Oxidizer Shutdown Root Cause Analysis Memorandum (September 18, 1994)

Re: *Thermal Oxidizer – Summary of Root Cause Analysis*

SRNE SUPERFUND SITE
PIPING & INSTRUMENTATION DIAGRAM
LIQUID TREATMENT SYSTEM

SRNE SUPERFUND SITE
 PIPING & INSTRUMENTATION DIAGRAM
 THERMAL OXIDIZER

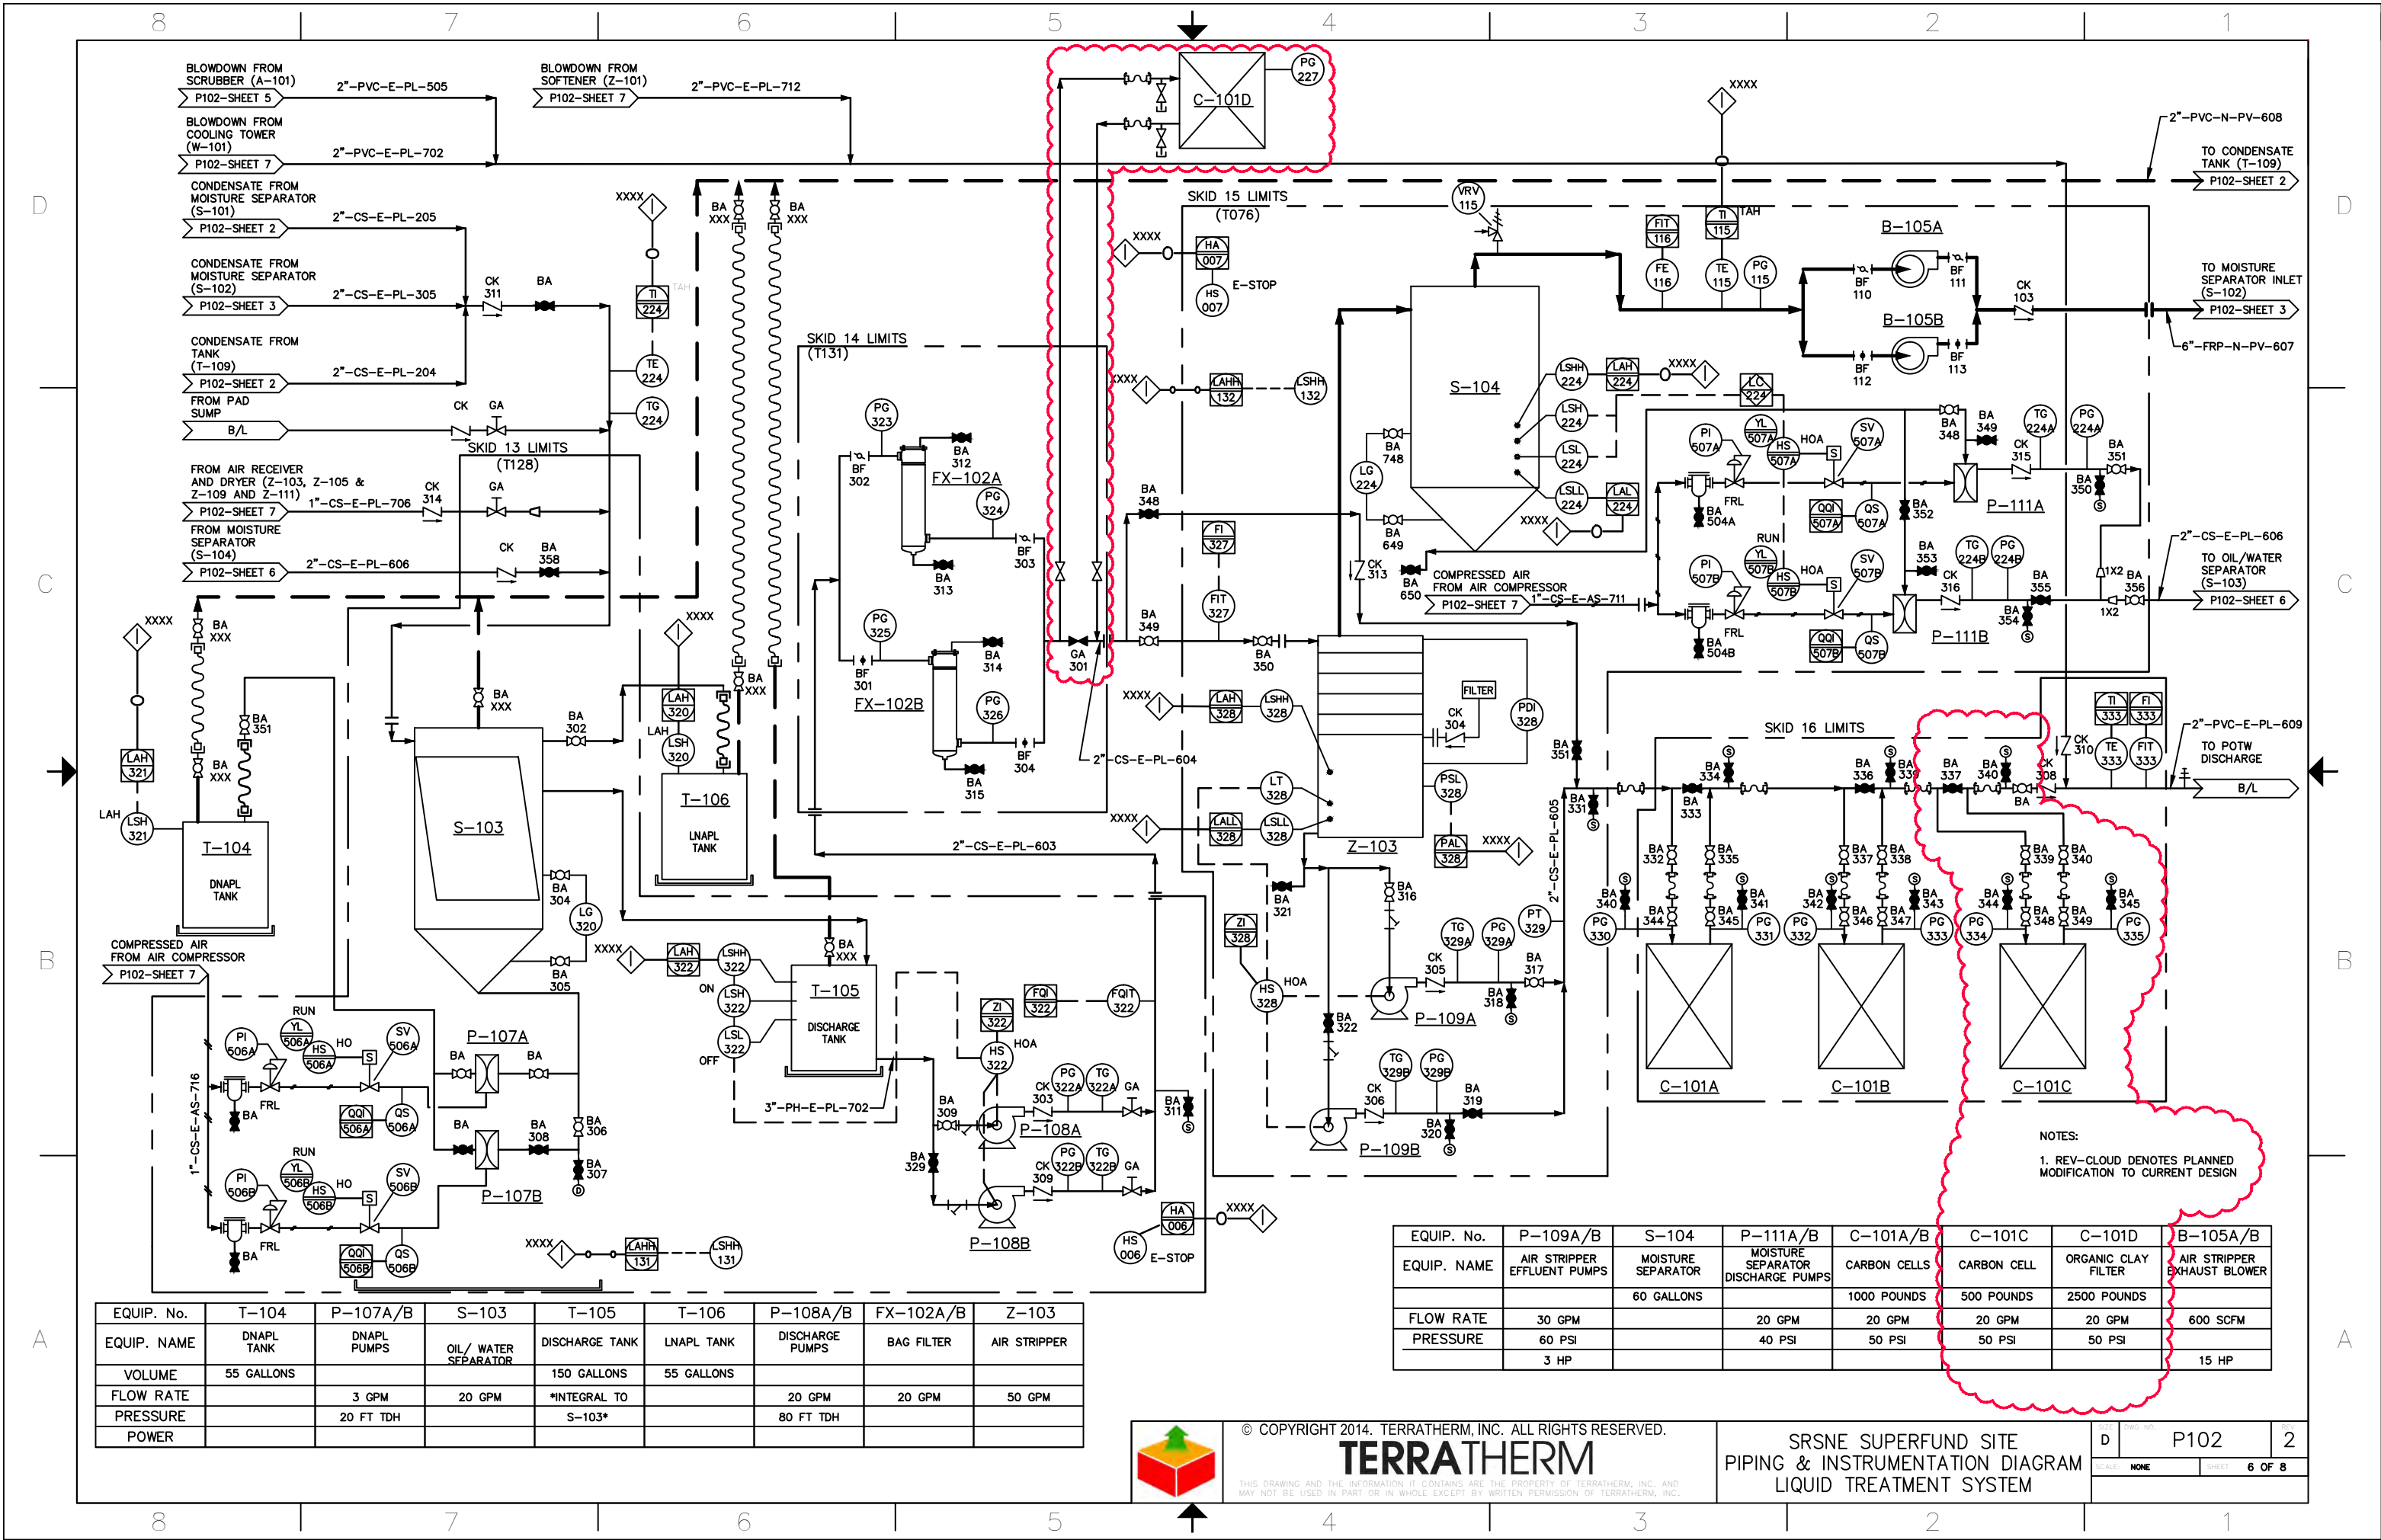
- CORRECTIVE ACTION: We have installed an organoclay media vessel downstream of the OWS to remove any free or emulsified oil from the OWS effluent. Once a day, the water color in the air stripper is inspected to confirm that the clay is not saturated. Spare clay is onsite. The mist eliminator in the air stripper was inspected, cleaned, and put back into service.

- An organoclay filter was added between the OWS and the air stripper to remove free or emulsified oil, and to reduce or eliminate any transient spikes in vapor concentrations related to fluid transfers between these two operations.
- A redundant LFL sensor was installed upstream of the heat exchanger and upstream of the dilution air blower. Like the primary unit, this device is programmed to alert operators with a warning alarm when 40% LFL is reached, and a shutdown alarm at 50%.

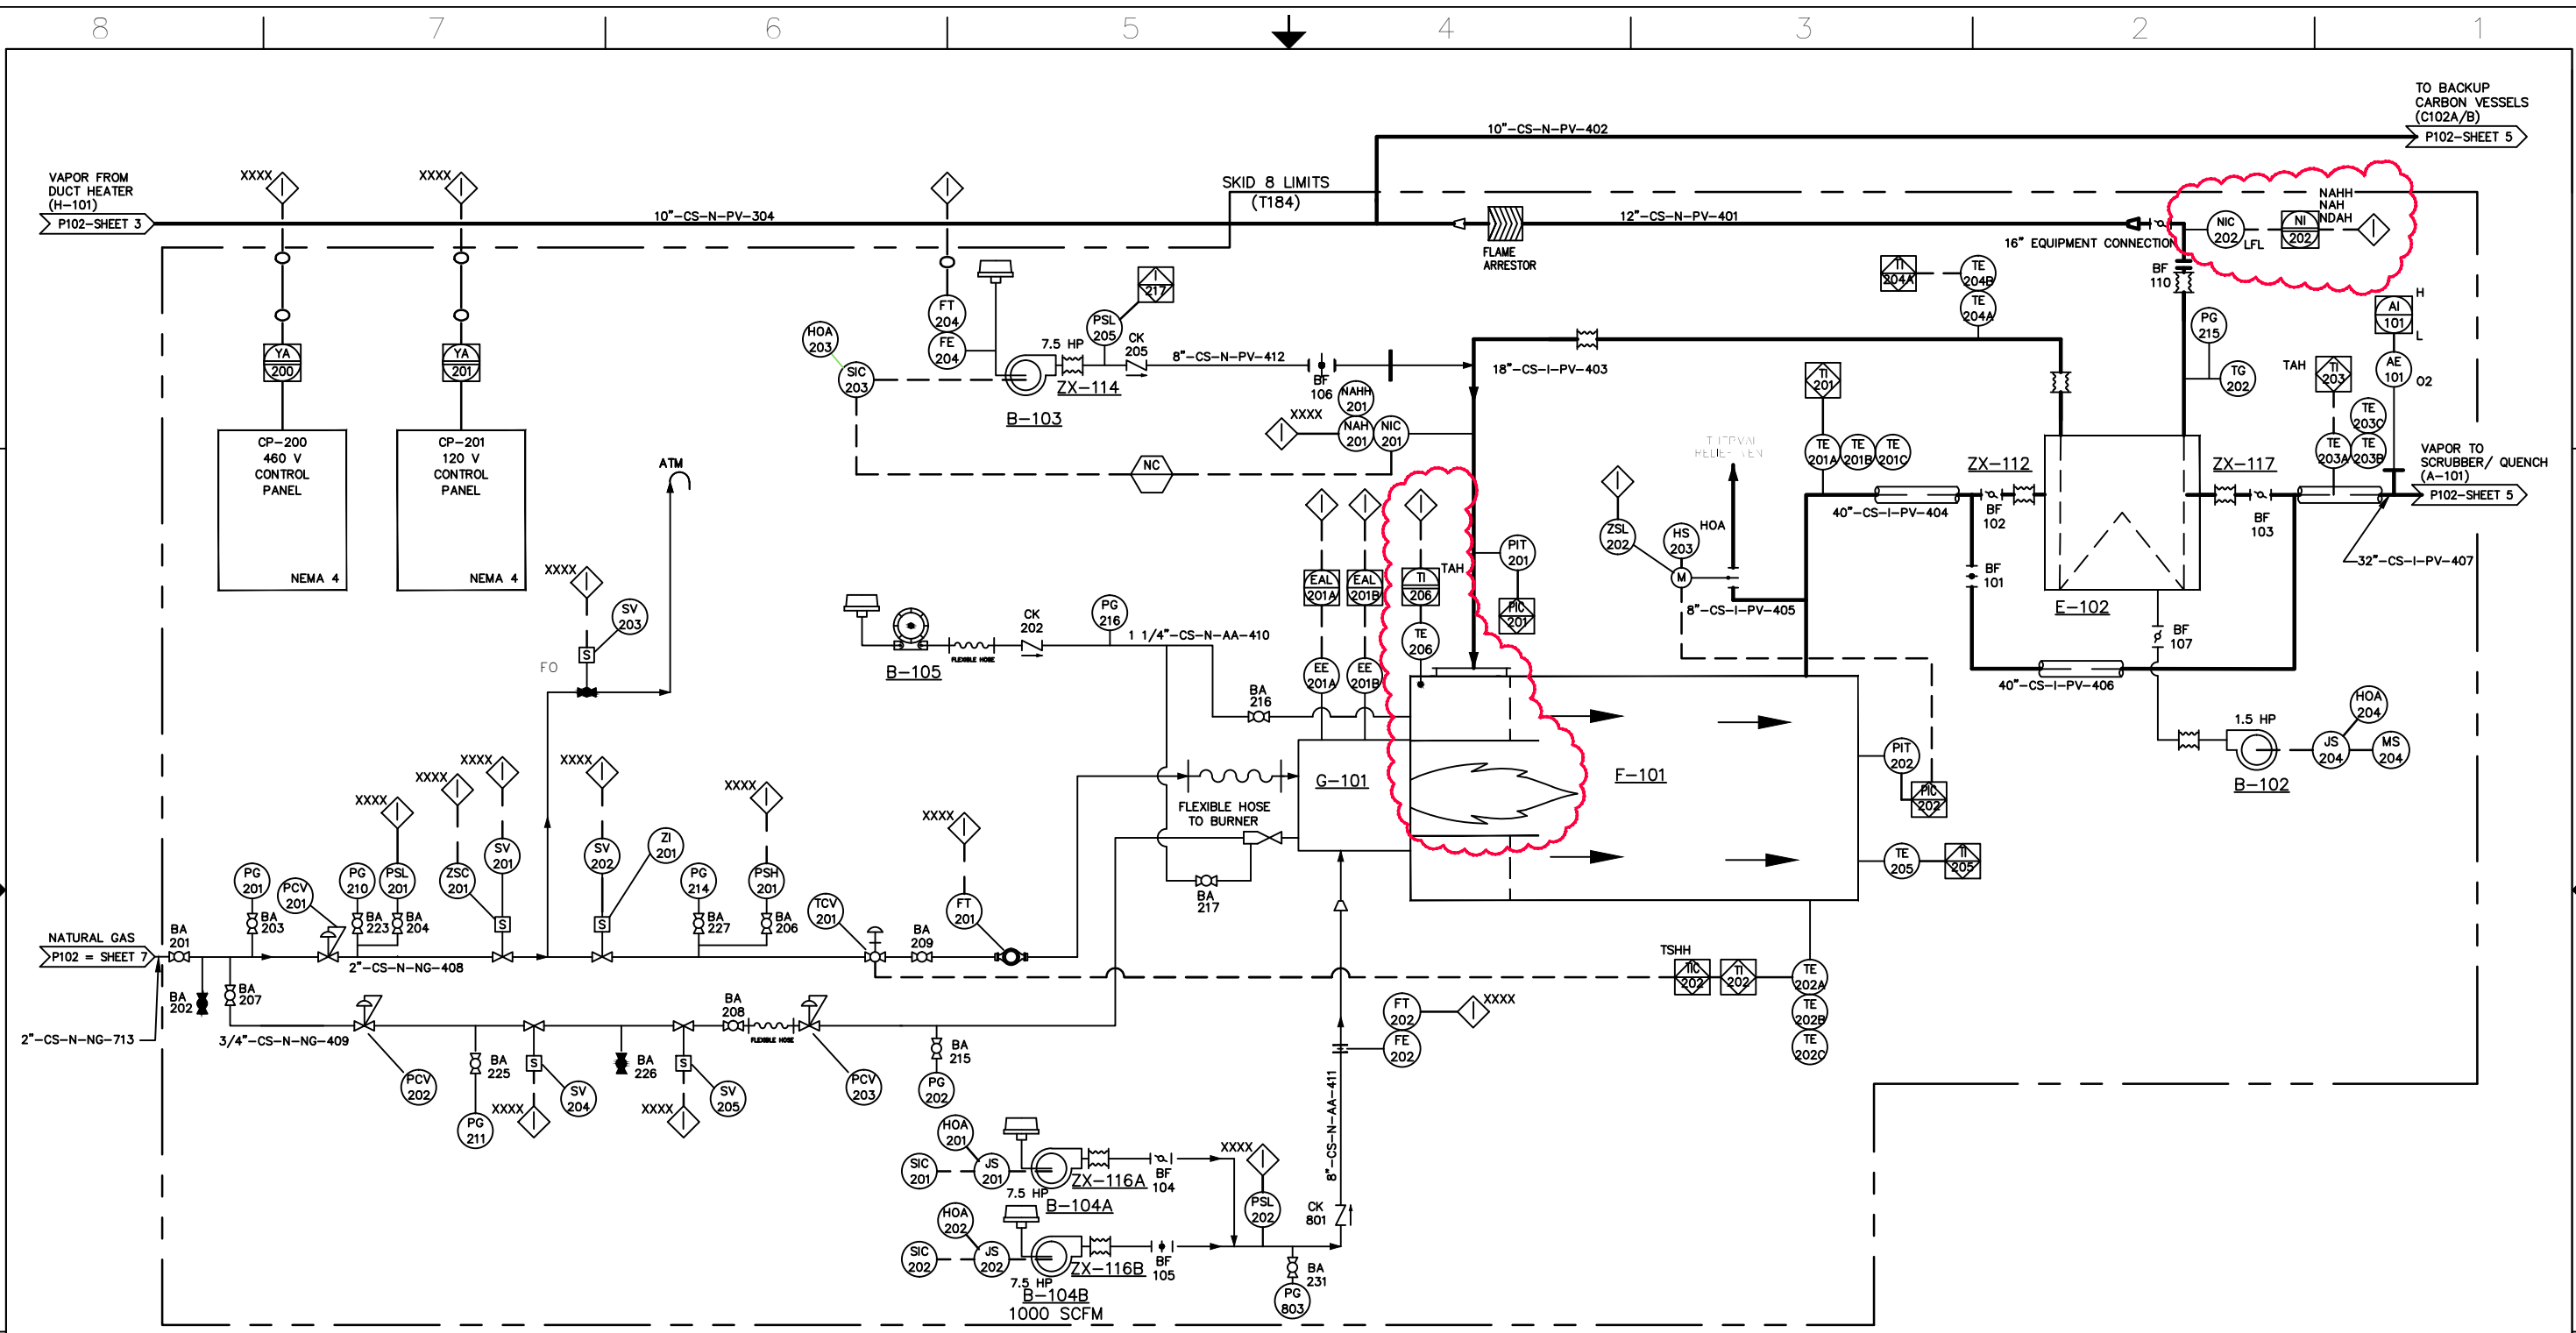
- CORRECTIVE ACTION: We have installed a new thermocouple sensor at the inlet to the oxidizer chamber and have programmed a high temperature shutdown alarm based on this device.

Additionally, a differential shutdown alarm will terminate operations if the readings from the two LFL sensors differ by more than 15%.

- The primary LFL sensor will continue to control the dilution air blower operation. The blower will idle whenever LFL levels are below 40%, and will speed up as LFL rise above this level.
- A temperature sensor was installed upstream of the daisy wheel to ensure that the inlet chamber temperatures remain close to the inlet process temperature. A shutdown Alarm is currently programmed to shut down operations if temperatures increase above 500°F in the inlet chamber to the oxidizer. Currently, the temperature of the process vapor as it enters the inlet plenum is approximately 220°F.
